**Re: Panoche Energy Center Project (06-AFC-5C)  
Replacement Pages for Petition to Amend**

## **Panoche Energy Center**

Petition to Amend Final Commission Decision

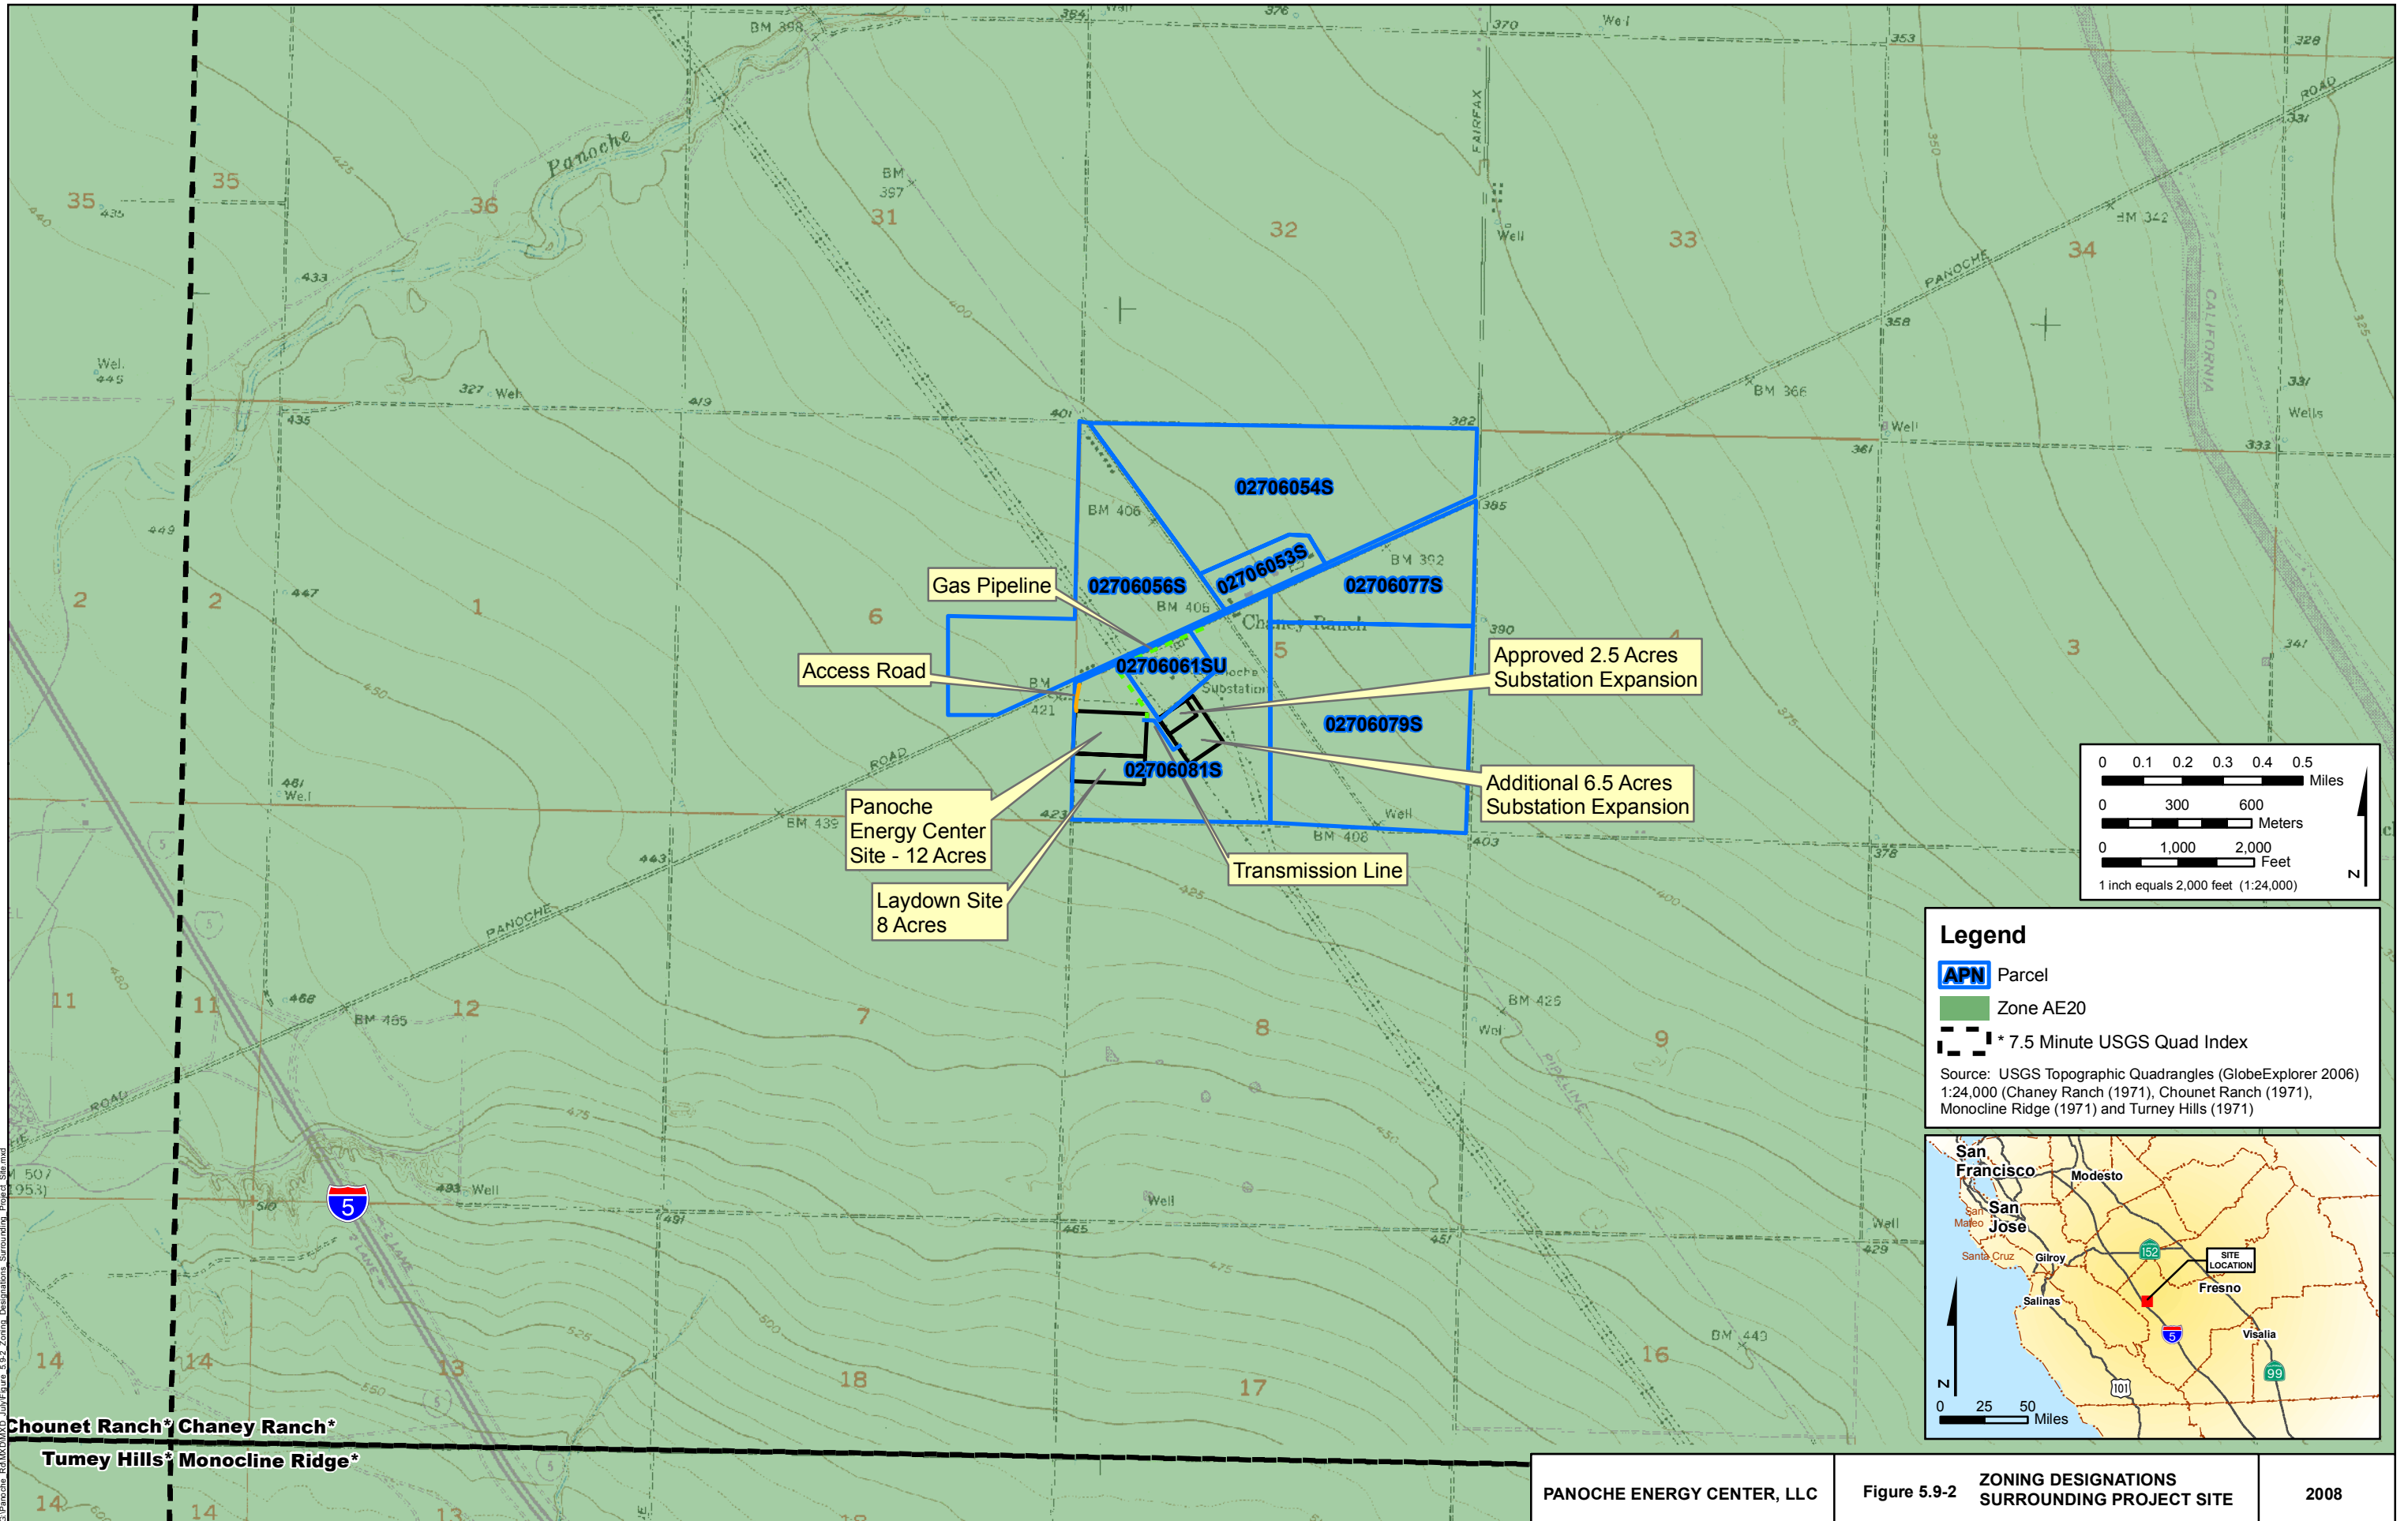
During review of the Land Use section of the Petition to Amend the California Energy Commission's Final Decision for the Panoche Energy Center ("Petition"), we noted a minor error in an assessors parcel number for a pertinent portion of land identified within the Petition. To that end, enclosed herein please find copies of the revised relevant page and figure (page 5-27 of the Petition and Figure 5.9-2 *Zoning Designation Surrounding Project Site*).

The affected environment of the Proposed Substation Expansion is the same as that for the approved PEC. As described in Section 3.0 of this Petition, the Proposed Substation Expansion involves 6.5 acres of land on the southwest corner of the existing Substation. The 6.5 acre Proposed Substation Expansion area would create a flag-shaped parcel of land adjacent to the previously approved PEC 2.5 acre Substation expansion area. The Proposed Substation Expansion footprint is within the same assessors parcel number as the approved PEC (~~027-060-78S~~ [027-060-81S](#)) and is currently used for agriculture, specifically pomegranate orchard.
